LANCER

Technical Bulletin

Volume 22, Issue 02, June, 2015

CED Product Line Compressor Conversion

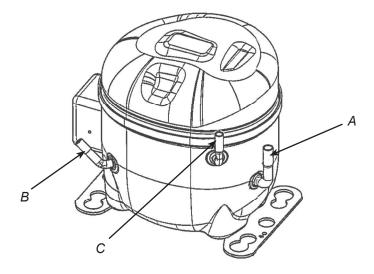
Tecumseh, the compressor supplier for Lancer's CED Product Line, has standardized the location of the inlet and outlet product lines of their compressors.

The compressors are the same, relating to performance, but the suction, discharge, and process lines have all been standardized, requiring Lancer to adapt to the new line locations and changing the line configurations, or the deck assembly design to incorporate the new compressor.

With keeping the same overall dimensions on the dispensers a requirement, backward compatibility for repair of older units requires a kit based on one of the options listed below:

Dispenser	Required Change
CED 1500 Delta	Keep the compressor in the same location. Requires new suction, discharge and process lines.
CED 500	Change the orientation of the compressor, requiring new suction, discharge, and process lines, along with a new base plate. Requires entire deck assembly to be replaced
FCOJ 2 Valve and 4 Valve	Change the orientation of the compressor or other deck assembly components. Requires entire deck assembly to be replaced.

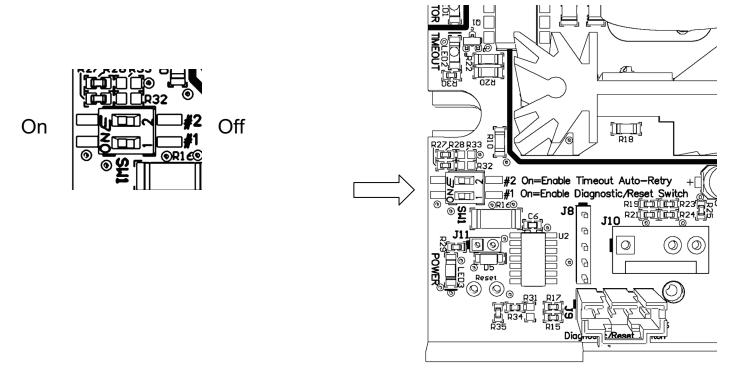
The Lancer carbonator has a time-out feature that, in the event of a disrupted inlet water flow, shuts off the motor after 3 minutes of unsuccessfully trying to pump water to fill carbonator. A disrupted water flow could be, for example, a problem with city water to the store. The Lancer carbonator now offers different options to reset the motor once water supply has been restored.

Manual Reset (Position 1): Restart the motor, by simply pushing the reset button.

Auto Reset (Position 2): 15 minutes after the motor shuts off, the feature will try to restart the motor. If still no water, the auto reset feature will try every 15 minutes for 3 hours until successfully starting the motor. During those 3 hours, the time out LED will blink slowly. See below for Timeout LED location.

After 3 hours with no water supply the motor remains off until the water problem has been corrected, and the timeout LED will blink quickly.

The default setting has both options, positions 1 and 2 enabled, so either will work.

If one option is preferred over the other, enable the position by turning the switch to "ON" and the other to "OFF".

^{**} These switches can be switched with a small screwdriver or a ballpoint pen. Toward the edge of the board is ON, toward the center is OFF.
